APPLICATION NO.	FILING DATE	FIRST NAMED INVENTOR	ATTORNEY DOCKET NO.	CONFIRMATION NO.
10/698,867	10/30/2003	George Paskalov	100798.0008US1	2026
24392	7590	08/22/2007		
FISH & ASSOCIATES, PC ROBERT D. FISH 2603 Main Street Suite 1050 Irvine, CA 92614-6232			EXAMINER WONG, EDNA	
			ART UNIT 1753	PAPER NUMBER
			MAIL DATE 08/22/2007	DELIVERY MODE PAPER

Office Action Summary	Application No. 10/698,867	Applicant(s) PASKALOV ET AL.	
	Examiner Edna Wong	Art Unit 1753

This is in response to the Amendment dated July 24, 2007. The text of those sections of Title 35, U.S. Code not included in this action can be found in a prior Office Action.

As shown in Applicants' Fig. 1:

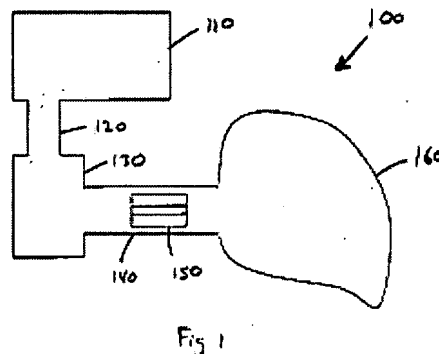
line 7, recites "without subjecting the waste directly to the plasma".

Applicants' specification, pages 1-6, does not mention without subjecting the waste directly to the plasma in the method. Thus, there is insufficient written description to inform a skilled artisan that applicant was in possession of the claimed invention as a whole at the time the application was filed.

However, there is sufficient written description for flowing the waste into conduit **140** where it is carried past the waves of the RF plasma generator **150** (page 4, lines 22-23). The conduit, which is substantially water tight, carries the fluid waste past the waves allowing it to be ***subjected to the waves*** for an amount of time that is sufficient to inactivate or kill a substantial amount of the microorganisms in the waste (page 5, lines 5-8).

the conduit **140** carries the waste in the vicinity of the RF plasma wave generator **150**. The waste would have been subjected directly to the waves produced by the RF plasma generator **150**.

The Examiner has carefully considered the entire specification as originally filed, however, there is found no literal support in the specification for the newly added limitation in amended claim 12. Applicants have not provided the page number and line numbers from the specification as to where the newly added limitations are coming from. *Ex parte Grasselli*, 231 USPQ 393 (Bd. App. 1983) *aff'd mem.* 738 F.2d 453 (Fed. Cir. 1984).
